DRAYTON SOUTH COAL PROJECT

Response to Submissions
May 2013

Volume 1
Main Report

RESPONSE TO SUBMISSIONS

Revised Air Quality Contours - Year 10

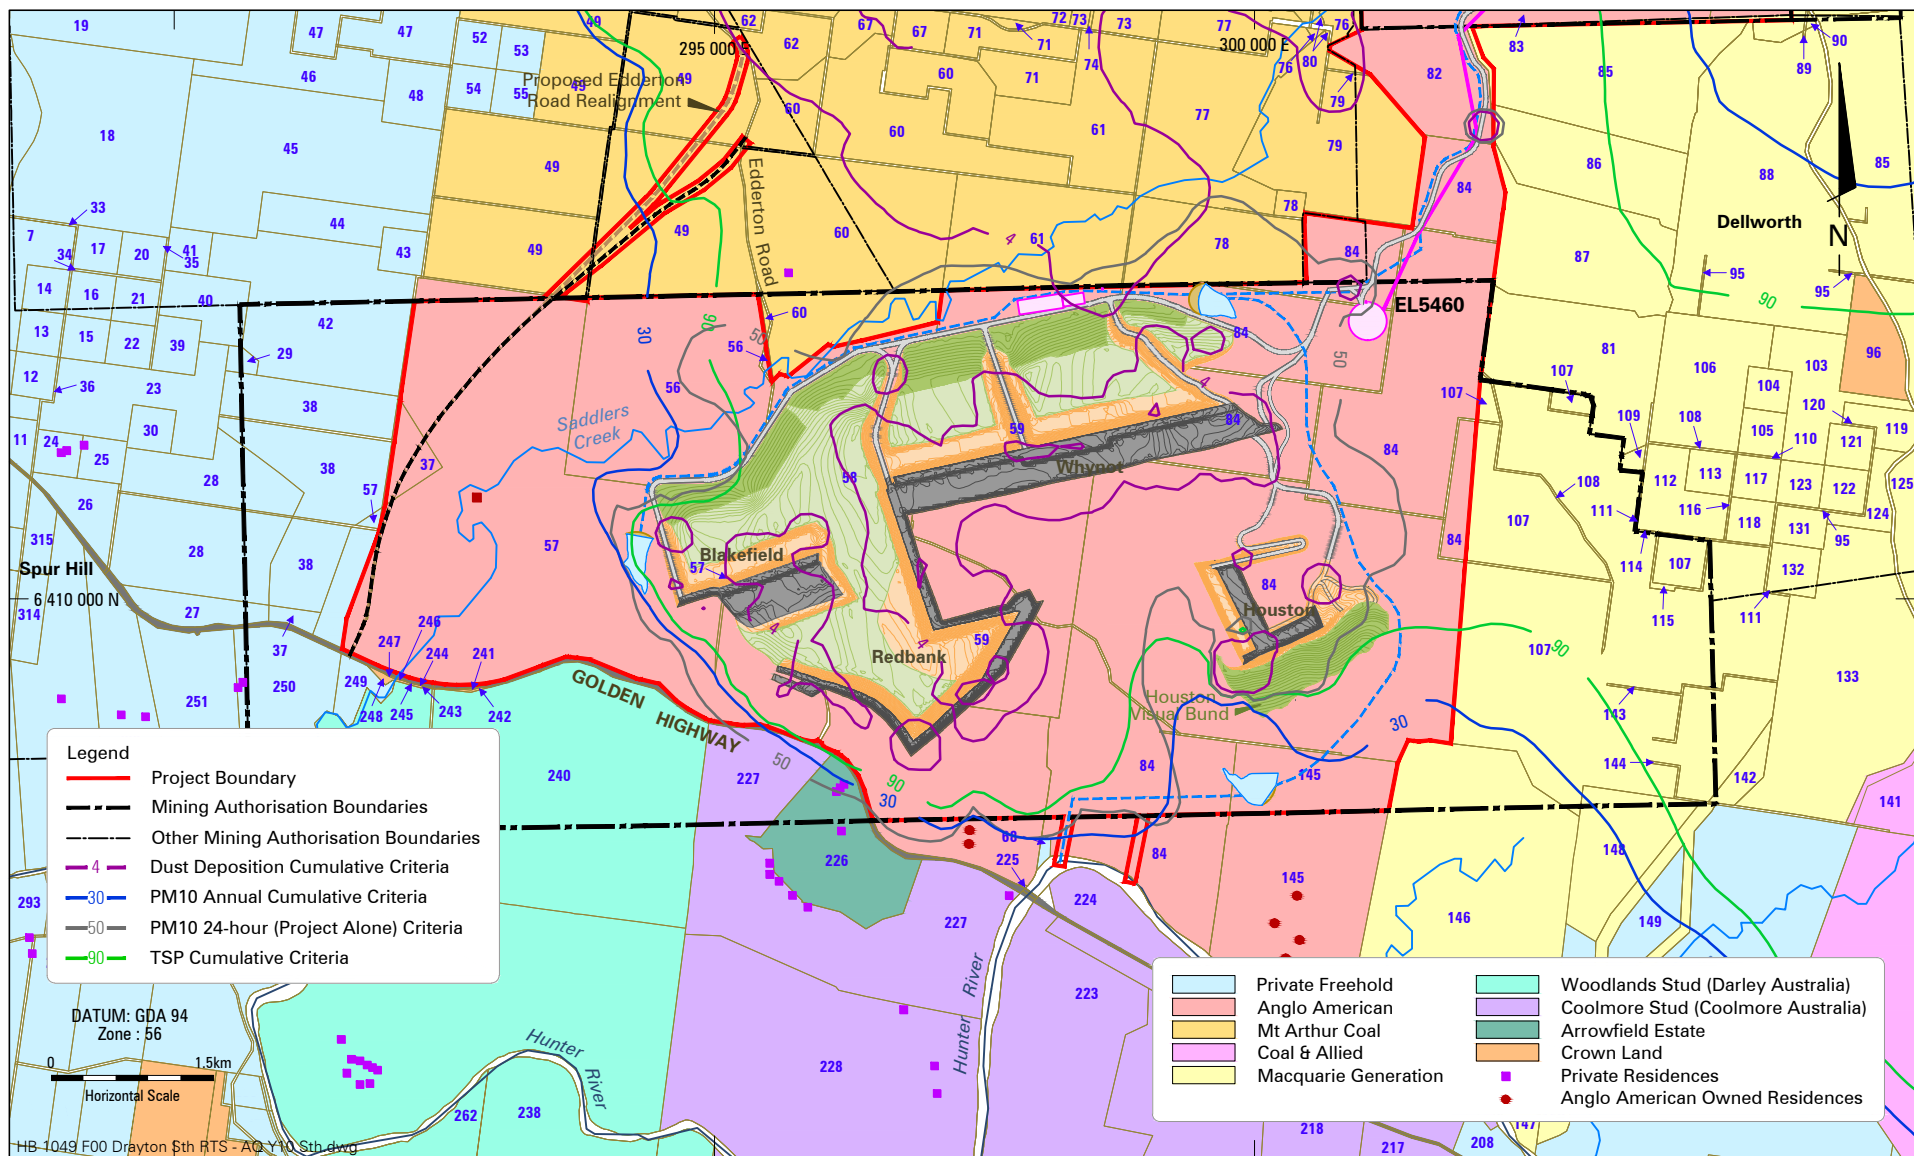
Figure 7 and **Figure 8** illustrate the air quality contours for predicted annual average Total Suspended Particulates (TSP), annual average PM₁₀, 24-h average PM₁₀ and annual average dust deposition concentrations in relation to neighbouring private receivers within the vicinity of the Drayton South area for Year 10 and 15, which represent the worst case years. See Figure 42 and 43 of the EA for a comparison with the original modelled results.

The results show a significant reduction in the maximum predicted 24-h average PM₁₀ ground level concentrations at a number of private residences compared with the original EA air quality modelling. Residences 226 (B and C) are predicted to experience exceedances of the 24-h average PM₁₀ assessment criterion of up to three days during Year 10 of the Project's operations. This represents a significant reduction when compared with the 23 days that was predicted to be in exceedance as part of the EA modelling. No exceedances of the assessment criterion are predicted in Year 15. It is proposed that the impacts at these locations would be managed via a real-time and/or predictive monitoring system where operations could be modified (or temporarily shut down in extreme cases) under certain meteorological conditions to minimise the impacts. No other residences are predicted to experience 24-h average PM₁₀ concentrations above the assessment criterion due to emissions from the Project alone.

The results from the revised dispersion modelling indicate that the annual average PM₁₀, TSP and dust deposition ground level concentrations are not predicted to exceed the relevant criteria from the project alone at any private residences. The revised cumulative

assessment also resulted in no exceedances at private residences and only one exceedance for a mine owned residence (PM₁₀ and TSP). There is an overall reduction in the predicted annual average concentrations at all other modelled residences due to the revised emission estimates.

Figure 9
Muswellbrook Central EPA Monitor – PM₁₀ Concentrations (21 October 2012)

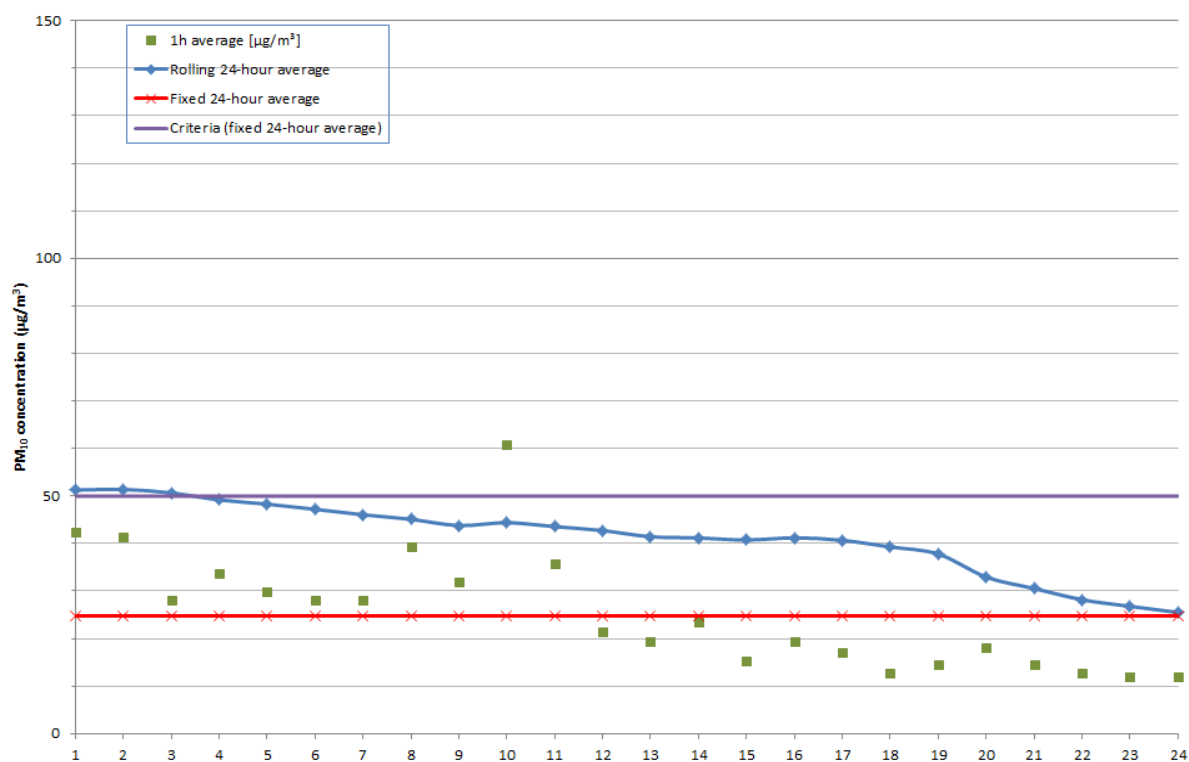
The alerts being provided by the EPA are based on a rolling 24-h average. This means that a single 1-h average spike in the monitoring data that could be caused, for example, by a vehicle idling close to the monitor, can result in an alert being sent that the criteria have been exceeded. Yet when the fixed period 24-h averages are calculated for the same day there is no exceedance of the criteria. This is demonstrated in **Figure 9** to **Figure 11**, which shows three days of data from the Muswellbrook Central EPA monitoring station, including the 1-h PM₁₀ average, rolling 24-h PM₁₀ average and fixed 24-h PM₁₀ average.

Based on the rolling 24-h average, an alert would have been sent at 1:00 am on 21 October 2012 given that a concentration of $51.3 \mu\text{g}/\text{m}^3$ was calculated (see **Figure 9**). It is EPA policy that an alert is only sent out for the first instance of an exceedance for that day. When compared against the air quality assessment criteria (based on the fixed 24-h average), a concentration of $24.7 \mu\text{g}/\text{m}^3$ was calculated, which is well below the criterion of $50 \mu\text{g}/\text{m}^3$.

Figure 13
Muswellbrook Central EPA Monitor – Average PM₁₀ Concentrations by Hour of Day (2012)

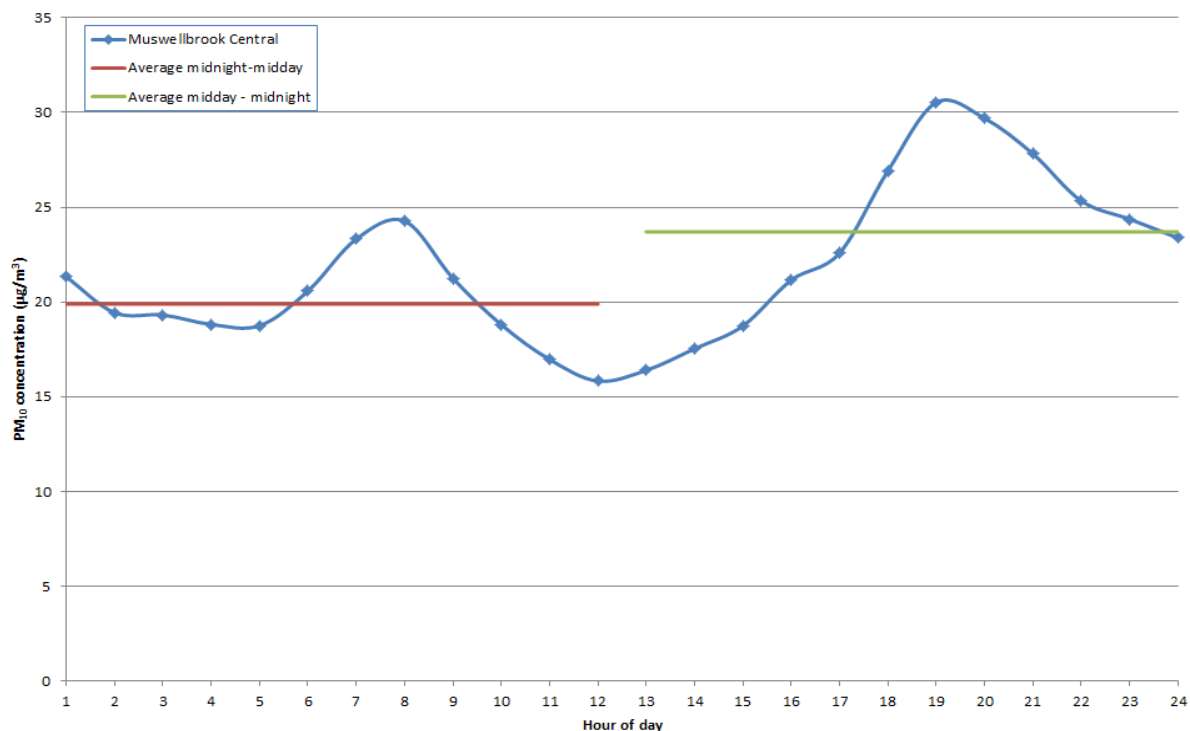
MSC submitted that 12:00 pm to 12:00 am dust readings have typically been higher than daytime readings. **Figure 13** presents the average of hourly PM₁₀ concentrations by hour of day for 2012, as measured at the Muswellbrook Central EPA monitor. This indicates that there is very little difference between the average PM₁₀ concentration measured between midnight and midday (approximately 20 µg/m³) and that measured between midday and midnight (approximately 24 µg/m³). However, there are clear peaks in the measured concentrations, which occur during both the morning and evening peak commuter travel times. It also noted that the average PM₁₀ concentrations decrease after 7:00 pm and don't start to increase again until 5:00 am.

The measured PM₁₀ concentrations depend not only the type and quantity of dust generating activities that are occurring but also the prevailing meteorology, predominately the stability of the atmosphere, which determines how well particle emissions disperse (or do not). Typically the atmosphere is more unstable during the daytime, resulting in better dispersion of particle emissions, and hence lower measured concentrations.
